Order by the Building Authority under section 24(1)

Order No : C/TF/000507/16/K Office of the Building Authority
 BD Ref : EB/4006/95/T04S 12/F - 18/F., Pioneer Centre,
 750 Nathan Road, Mongkok,
 Kowloon.
 To : The Owner of
8TH FLOOR OF 38 PLAZA NO.38 SHANTUNG STREET
KOWLOON Date: 18 March 2016

Owner(s) of the premises at 8TH FLOOR OF 38 PLAZA NO.38 SHANTUNG STREET KOWLOON
 on (Lot Number) K.L.L.10514 R.P.

8TH FLOOR PLAN

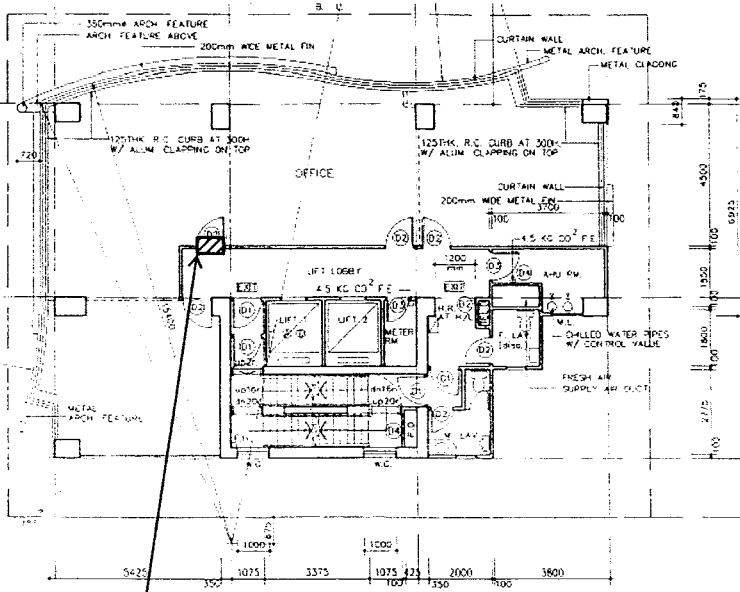
- (i) **A fire-resisting door at the entrance of the premises removed and replaced by a door of inadequate fire rating..**

2. For the said building works:
- (a) As a result of the building works at items (i) above, Regulation 90 of the Building (Construction) Regulations, which requires the building to be designed and constructed so as to inhibit or provide adequate resistance to the spread of fire and smoke; and to maintain stability of the building in case of fire, has been contravened.

Item (1) as Hatched Black
 黑影線所示的第(1)項

3. In exercise of the powers vested in me under section 24(1) of the Buildings Ordinance, I hereby order you to :-
- (a) reinstate the parts of the building so affected by the building works under item (i) above in accordance with the ~~*plans approved by the Building Authority / minor works completion record submitted to the Building Authority.~~
